# Access Compliance Report

## Public Rights-of-Way

Intersection ID: 10952	Main Street: N_GRAHAM_ST	Cross Street: STATESVILLE_AV	Location: S
ADA ID: 7076C34055DB	Ramp Type: Perp	Initial Pass/Fail: Fail	Overall Compliance: No
Severity Score: 8.75			
Codes/Mitigation Info/Possible Solution		Field Measurements/Component Compliance

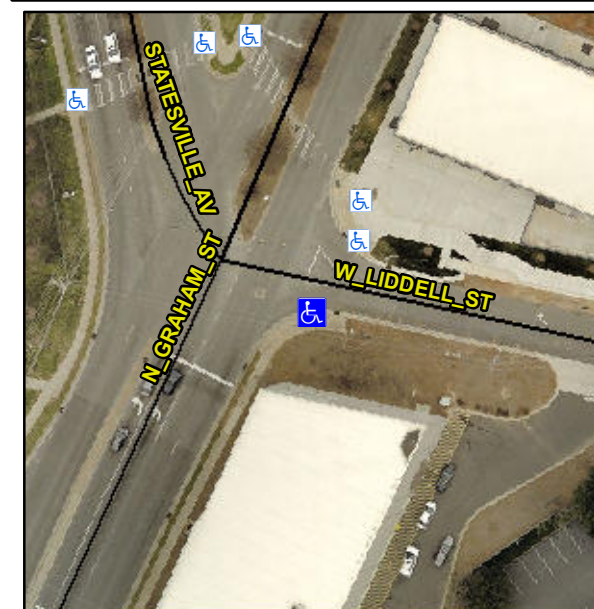
**Not Found, R304.5.1**

Compliance	Description	Data	Compliance	Description	Data
N/A	Ramp Length (in)	35.5	Yes	Ramp Slope (%)	8.0
No	Ramp Width (in)	42.0	Yes	Ramp XSlope (%)	1.4
N/A	Flare Type LT	N/A	N/A	Flare Type RT	N/A
N/A	Flare Slope LT (%)	N/A	N/A	Flare Slope RT (%)	N/A
N/A	Flare Traversable LT?	N/A	N/A	Flare Traversable RT?	N/A
N/A	Landing Length (in)	N/A	N/A	DWS Provided?	N/A
N/A	Landing Width (in)	N/A	N/A	DWS Contrast?	N/A
N/A	Landing Slope (%)	N/A	N/A	DWS Length (in)	N/A
N/A	Landing X Slope (%)	N/A	N/A	DWS Full Width?	N/A
N/A	Landing Curb? (Y/N)	N/A	N/A	DWS Offset (in)	N/A
N/A	Shared Landing?	N/A			
N/A	Gutter Ponding?	N/A	N/A	Gutter Slope (%)	N/A
N/A	Gutter Lip Ht (in)	N/A	N/A	Gutter X Slope (%)	N/A
N/A	Painted X Walk1?	No	N/A	Painted X Walk2?	N/A
	X Walk 1 Direction	To NE		X Walk 2 Direction	N/A
N/A	X Walk 1 Width (in)	N/A	N/A	X Walk 2 Width (in)	N/A
	X Walk 1 Slope (%)	2.4		X Walk 2 Slope (%)	N/A
	X Walk 1 X Slope (%)	1.1		X Walk 2 X Slope (%)	N/A

**Remove & Replace Entire Ramp.**
